# SensorLab Status Word Endianness Inconsistency

# PLC Data – SLS Output Register via EIP Generic Module Connection (configured Low-byte first)

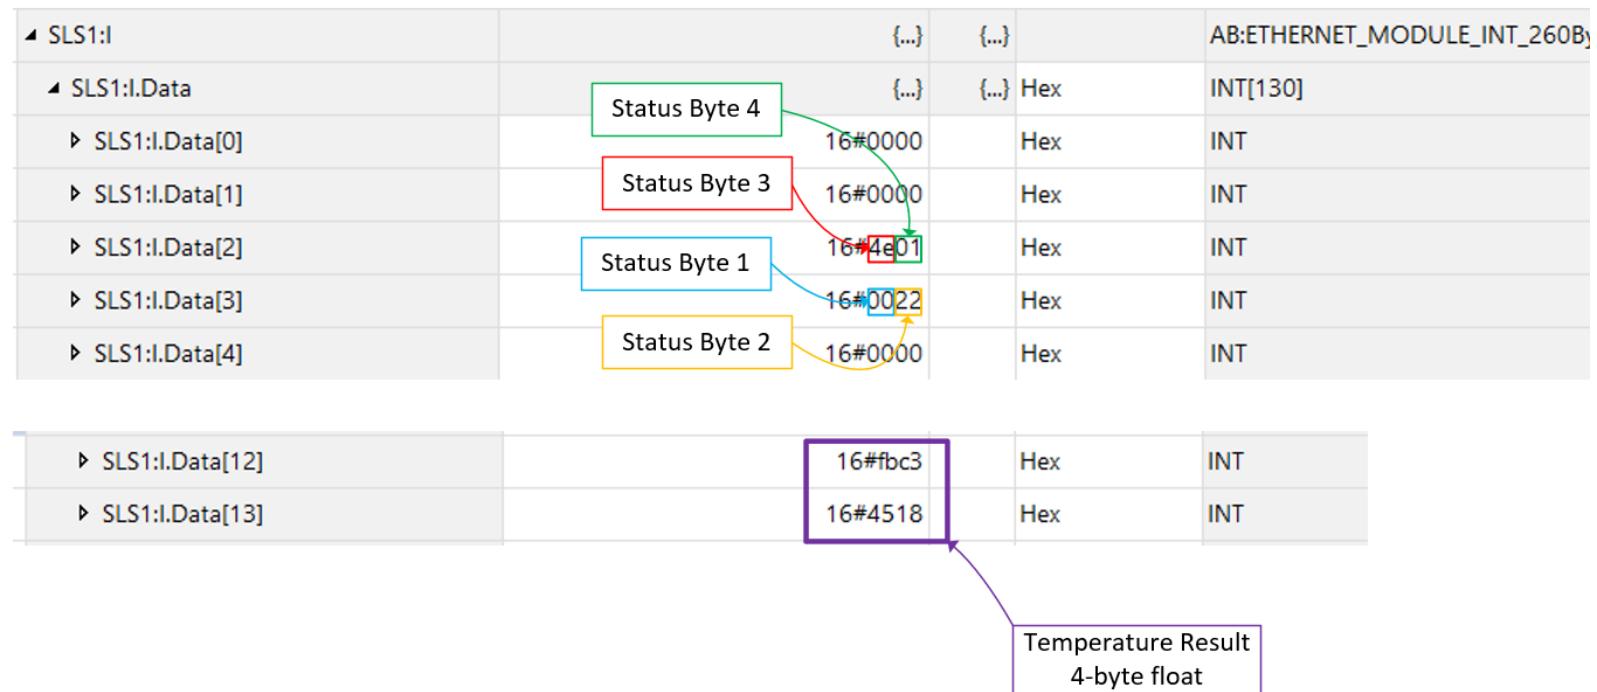
- The result fields (e.g., Temperature 4-byte float, etc) decode correctly in the PLC and the raw words show little-endian byte order.
- However, the status word/bytes **still arrive high-byte-first**, i.e., their byte order doesn't follow the low-byte-first setting.

# PLC Data - SLS Custom Telegram via serial → EIP (Anybus ABC3007-A)

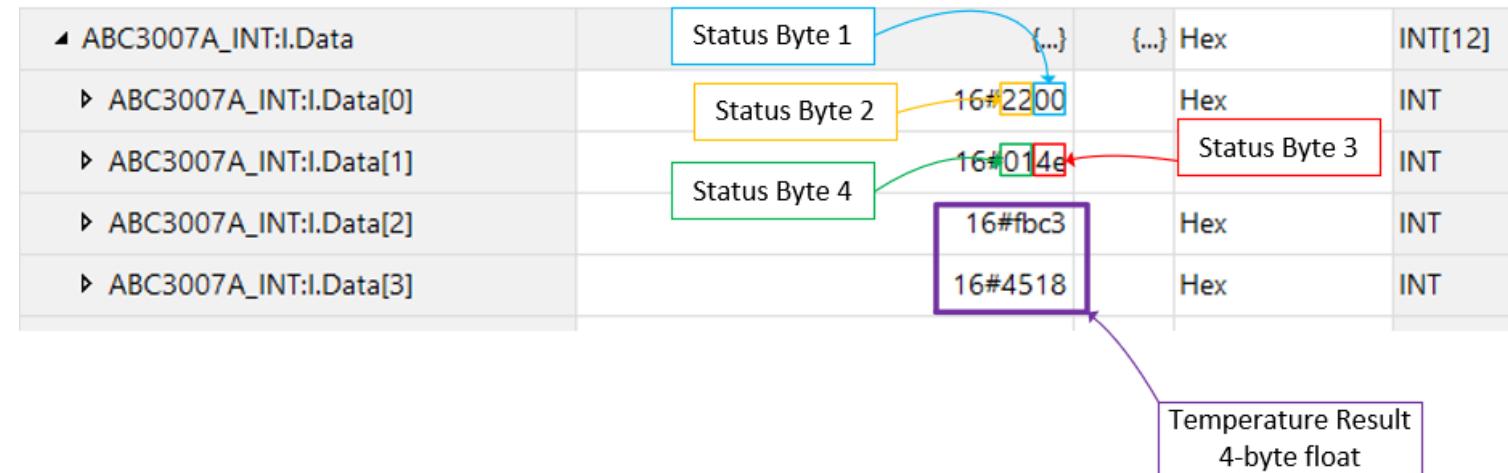
- Both the result fields (e.g., Temperature 4-byte floats, etc) and the status bytes decode correctly in the PLC as low-byte-first; the raw words show little-endian order.
- Note: the telegram editor **does not offer a big-endian option for status words**—only result fields allow endianness selection.
